DOCUMENT CHANGE REQUEST

DCR number 324	Changes required for: General	Originator: S JEFFERY
Date: 2007/02/21	Date sent: 2007/02/21	Organisation: ESA/ESTEC
Status: IMPLEMENTED

Title:	Transistors High Power NPN, based on type BUX77		
Number:	5203/016	Issue:	1

ESCC Detail Specification No. 5203/016

Maximum Safe Operating Area Graph

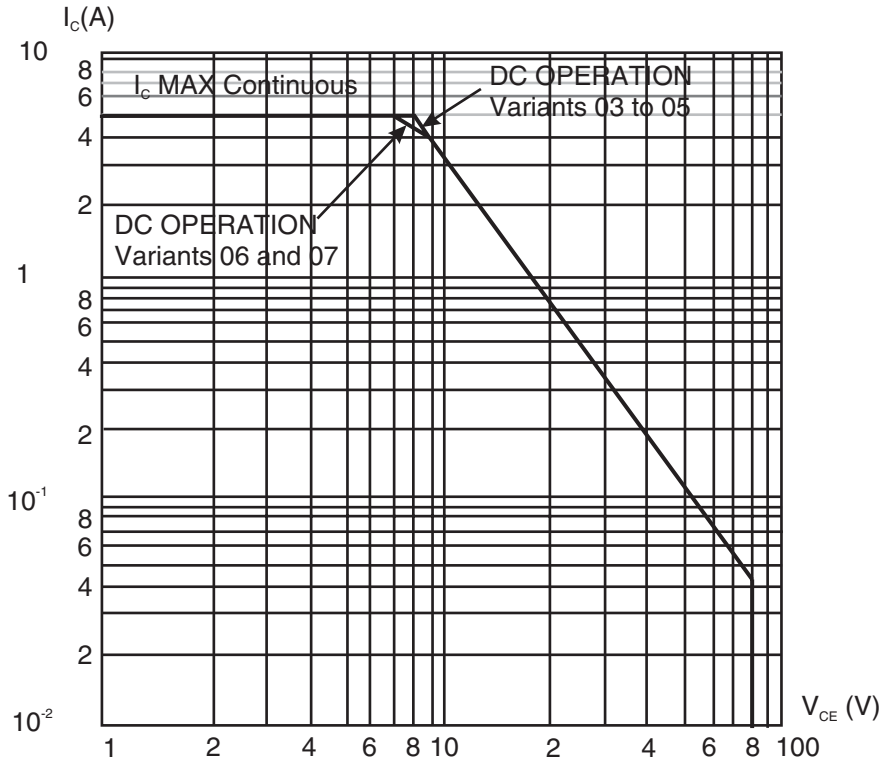
6. Figure 1(b) Forward Bias Safe Operating Area (Continuous DC) amended and moved to be a note in the Maximum

1.7.1 Metal Flange Mount Package (TO-66) - 2 lead

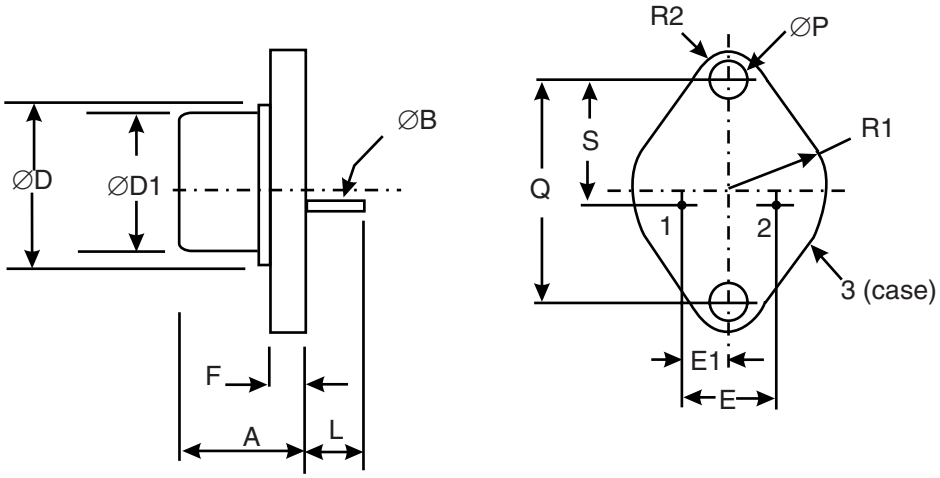
8. Figure 2 re-named â..Physical Dimensions and Terminal Identificationâ.; Figure 2(a) amended to reflect the TO-66 package currently supplied; Figure 2(b) amended to reflect the TO-257 package currently supplied. Consolidated notes added.

9. Para. 4.4.1 Case requirements corrected to reflect TO-66 and TO-257 metal flange mount packages.

VOLTAGE WAVEFORMS

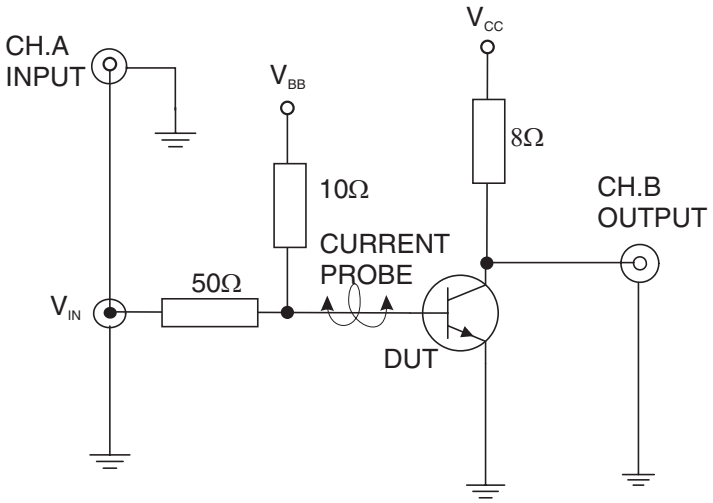
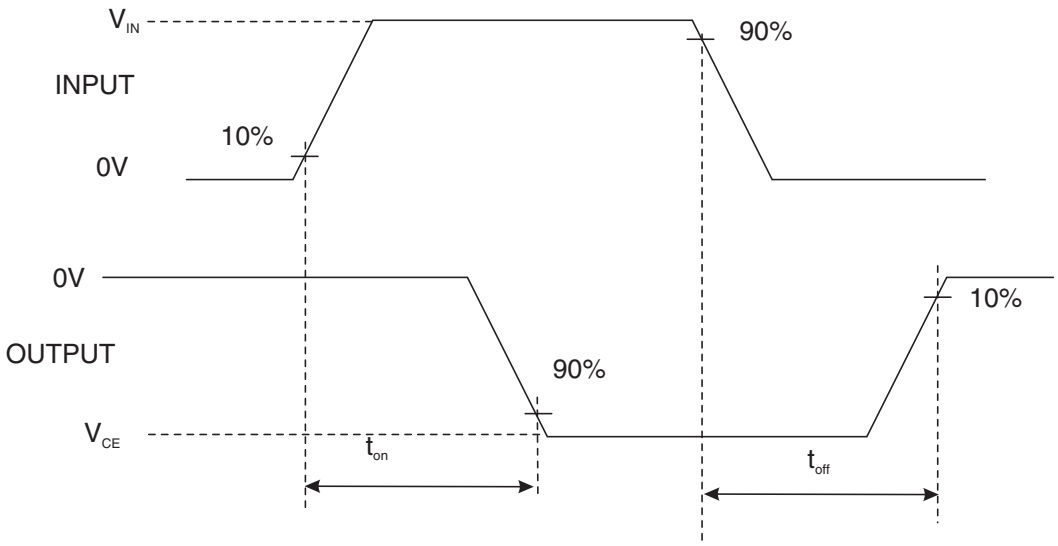
17. Table 2 and Figure 4: The Switching Times characteristics have been amended to reflect the new format.
